Access Compliance Report

Public Rights-of-Way

(Curb Ramps)

Intersection ID: 46817	Main Street: ARBOR_VISTA_DR	Cross Street: HOLM_OAK_PL	Location: NW
ADA ID: 3AA0BD43BBEB	Ramp Type: PerpDiag	Initial Pass/Fail: Fail	Overall Compliance: No
Severity Score: 30			
Codes/Mitigation Info/Possible Solution		Field Measurements/Component Compliance

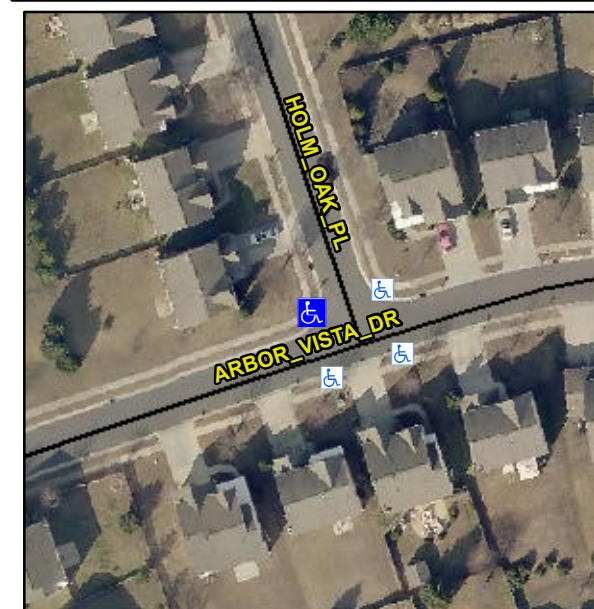
Not Found, R304.5.1, R304.2.2

Compliance	Description	Data	Compliance	Description	Data
N/A	Ramp Length (in)	43.5	No	Ramp Slope (%)	10.2
No	Ramp Width (in)	32.5	Yes	Ramp XSlope (%)	0.6
N/A	Flare Type LT	N/A	N/A	Flare Type RT	N/A
N/A	Flare Slope LT (%)	N/A	N/A	Flare Slope RT (%)	N/A
N/A	Flare Traversable LT?	N/A	N/A	Flare Traversable RT?	N/A
N/A	Landing Length (in)	N/A	N/A	DWS Provided?	N/A
N/A	Landing Width (in)	N/A	N/A	DWS Contrast?	N/A
N/A	Landing Slope (%)	N/A	N/A	DWS Length (in)	N/A
N/A	Landing X Slope (%)	N/A	N/A	DWS Full Width?	N/A
N/A	Landing Curb? (Y/N)	N/A	N/A	DWS Offset (in)	N/A
N/A	Shared Landing?	N/A			
N/A	Gutter Ponding?	N/A	N/A	Gutter Slope (%)	N/A
N/A	Gutter Lip Ht (in)	N/A	N/A	Gutter X Slope (%)	N/A
N/A	Painted X Walk1?	No	N/A	Painted X Walk2?	No
	X Walk 1 Direction	To S		X Walk 2 Direction	To E
N/A	X Walk 1 Width (in)	N/A	N/A	X Walk 2 Width (in)	N/A
	X Walk 1 Slope (%)	2.6		X Walk 2 Slope (%)	0.1
	X Walk 1 X Slope (%)	0.3		X Walk 2 X Slope (%)	2.3

Remove & Replace Curb Ramp With Two New Directional Ramps or Equivalent.
